STAFF REPORT

REGIONAL CENTER HEARING EXAMINER - HIGH IMPACT CASE

Case Number	2024-REG-038
Address (approx.)	752 East Market Street and 730 Washington Street
Location	Center Township, Council Districts #13 and #18
Petitioner	1820, LLC, by Jeremy Stephenson
Zoning	CBD-2 (RC)
Request	Regional Center Approval for the renovation of two former industrial buildings into mixed-use structures, with new windows and masonry reconstruction, and providing for 30,000 square feet of commercial space, 213 dwelling units, amenities and utility space, and reconfigured surface parking areas.

SITE PLAN, SOUTH BUILDING
SCALE = 1/40

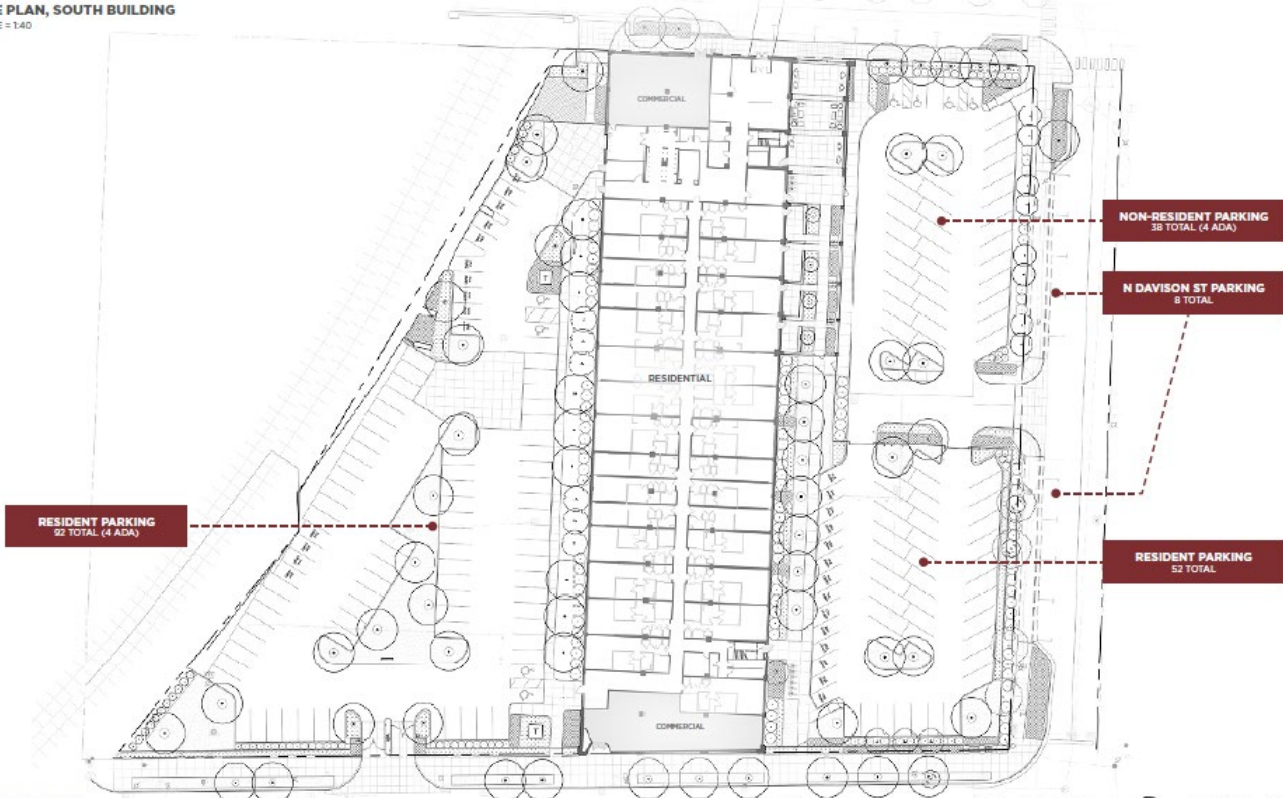
5. No details or locations of bicycle parking, either for interior storage for residents or outdoor bicycle locations for visitors, were submitted to the file. An amended site plan and floor plan noting these locations shall be submitted and subject to staff review and approval, prior to the issuance of an Improvement Location Permit. These Guidelines apply: CA 4.2.1, CA 4.2.2, and CA 4.2.4.

7. An expanded surface parking area is proposed along the corner of Market Street and Davidson Street, east of Cole South. Guidelines SC 3.2.3, SC 3.4.1, and SC 3.4.4 recommend or require that new surface parking areas be behind structures, or not along pedestrian ways. This expanded parking area would be screened with at least eight feet of landscaping along public streets, plus the existing parking areas, which also front public streets and do not currently have landscaped screening, would be screened, with this request. Therefore, staff supports the proposed deviation of these Guidelines.

EXTERIOR ELEVATIONS: SOUTH BUILDING
COLE MOTOR REDEVELOPMENT
30 JUNE 2024

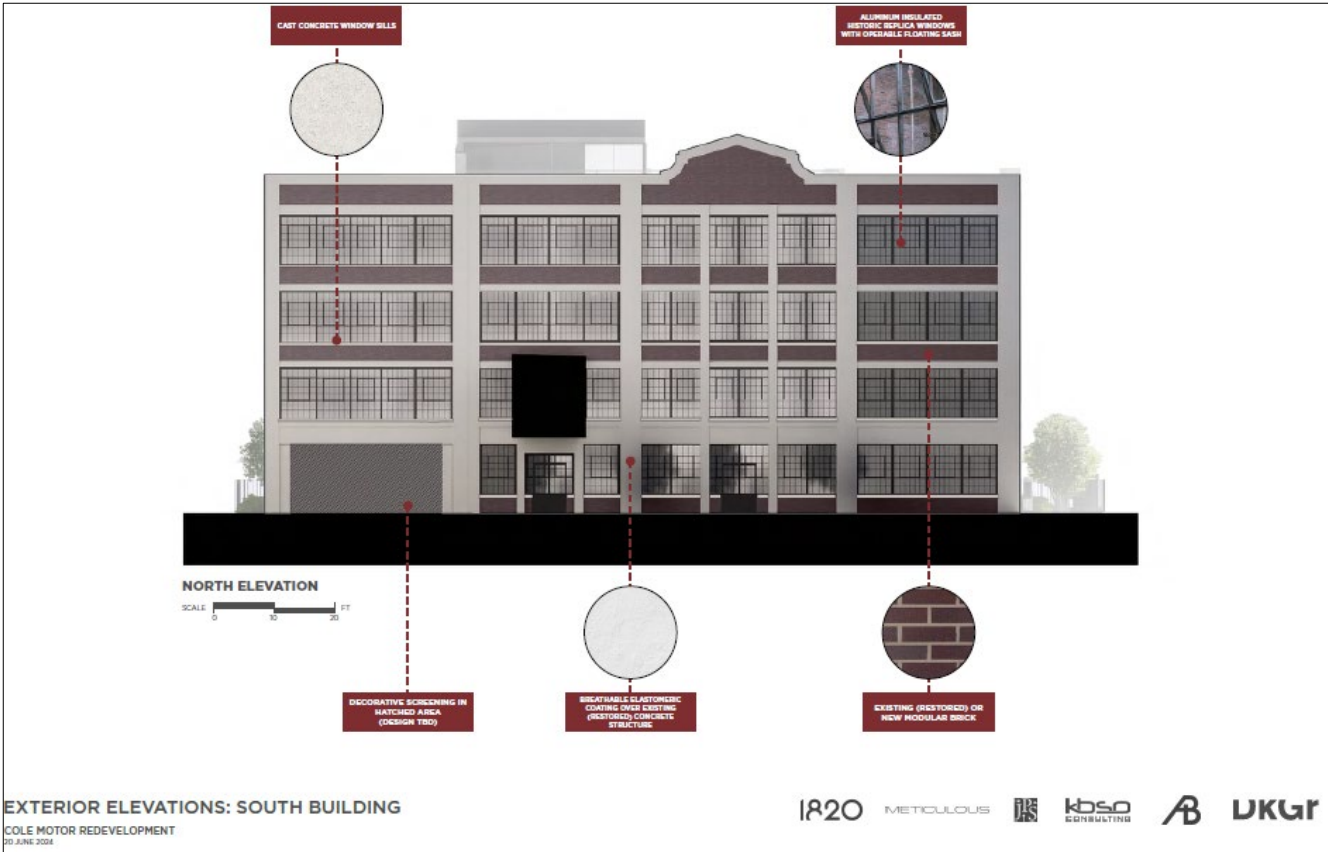
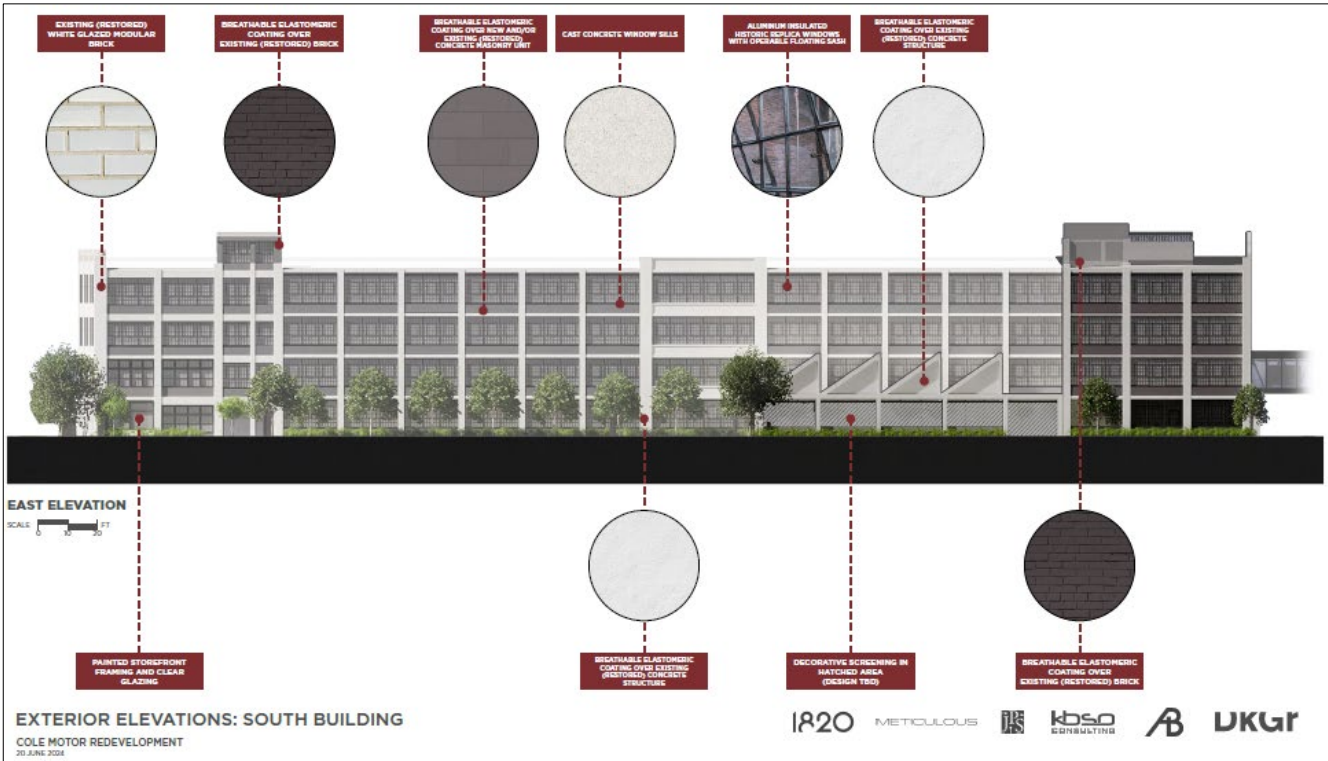
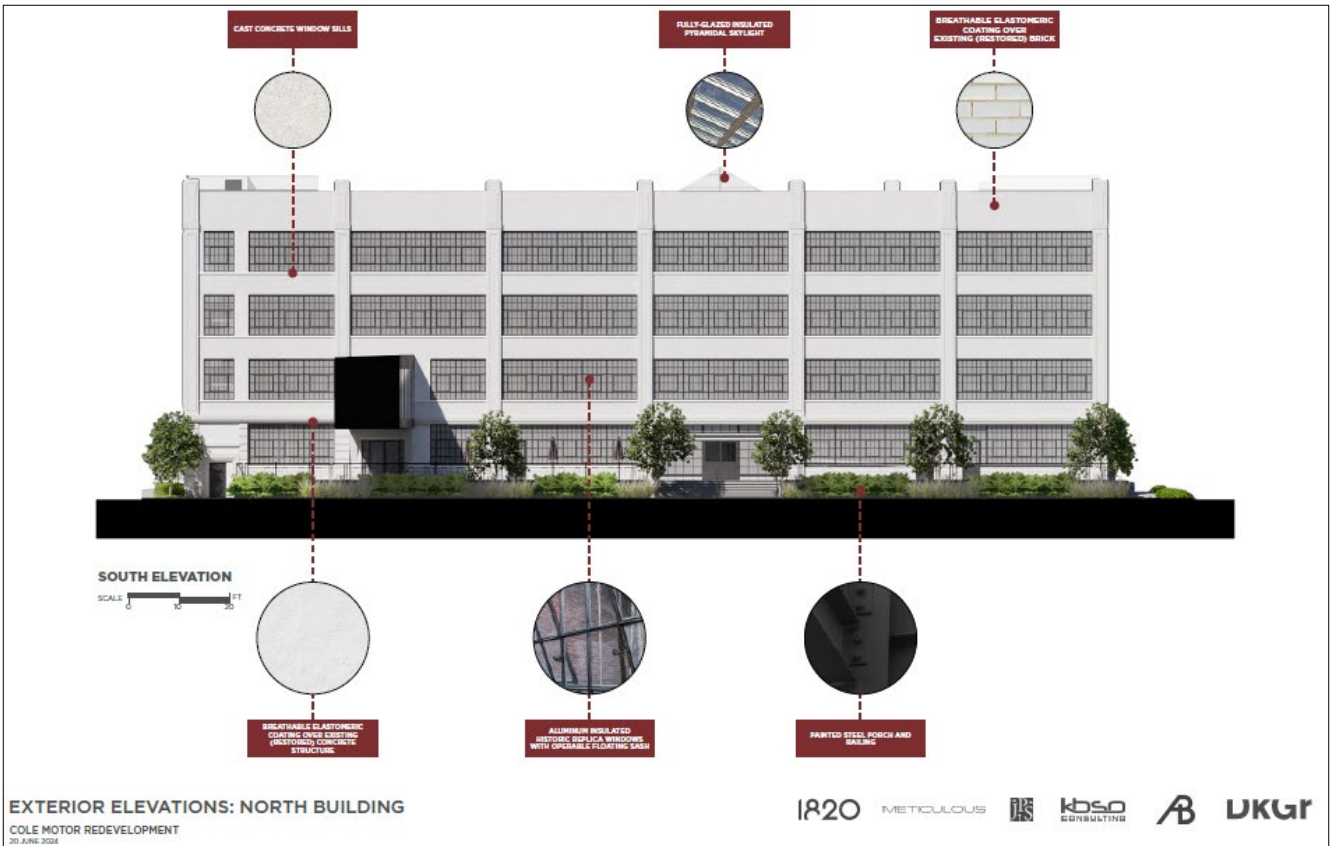
1. The submitted elevations do not provide details of some material items, such as the proposed decorative screening along the north and east elevations of the Cole South building. Therefore, scaled elevation drawings shall be submitted and subject to planning staff review and approval prior to the issuance of an Improvement Location Permit. Guidelines CA 2.1.1, CA 2.1.6 and CA 2.2.1 apply.
